Amendment to the Drawings:

REMARKS

U.S. Patent Application No. 10/777,782
Annotated Sheet

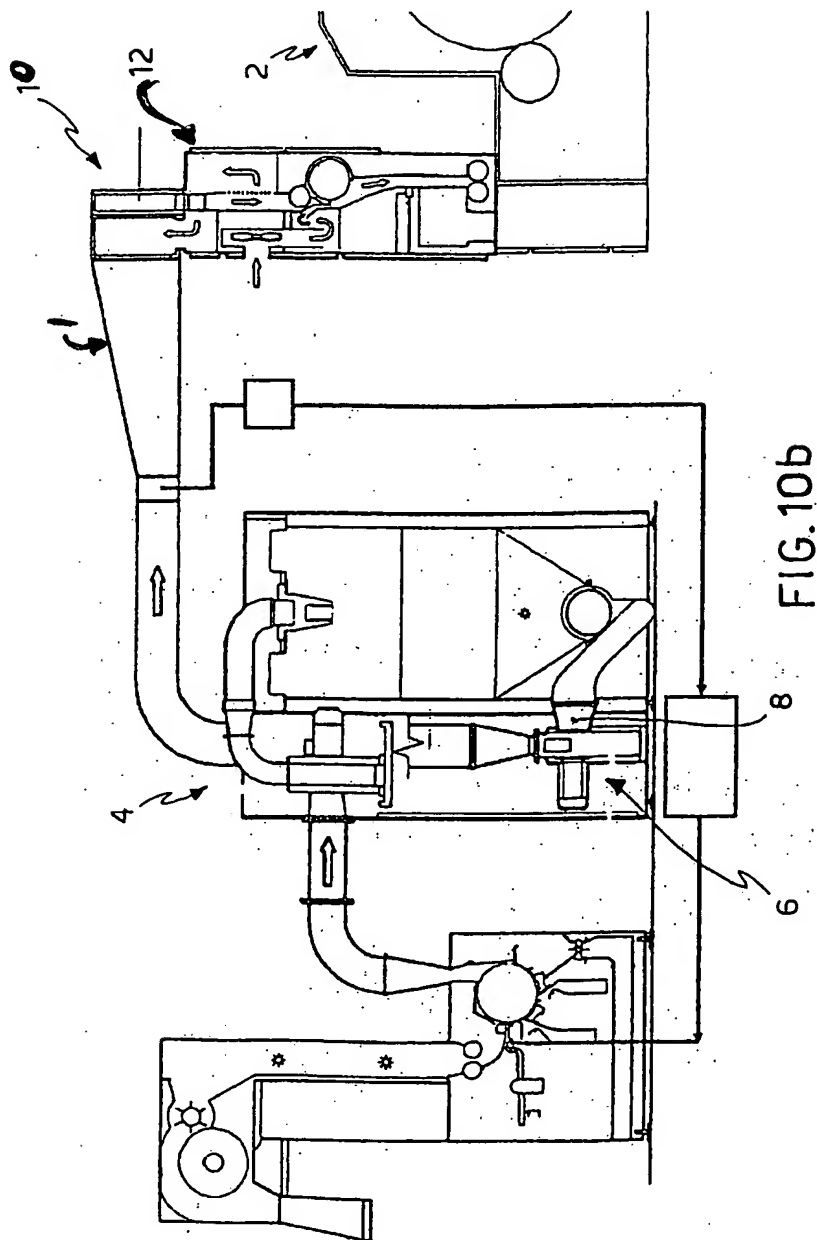
The attached drawings sheets include changes to FIGS. 10A -10B and FIGS 11A-11C.
Specifically, omitted element 10 has been added, as described in the specification.

Applicants propose to amend Figures 10A-10B and 11A-11C to add omitted element 10 (the distributor/connector) and to correct the locations of elements 1 (air ducts), 2 (carding machine), and 12 (down shoot to the Carding Machine 2). In particular, the figures have been amended according to the specification at pages 4 and 5 that describes the carding machines 2 as being connected in a substantially linear series to receive a singular air flow along the air ducts 1. the connector 10 connects the air ducts 1 to the down shoot 12 of carding machine 2.
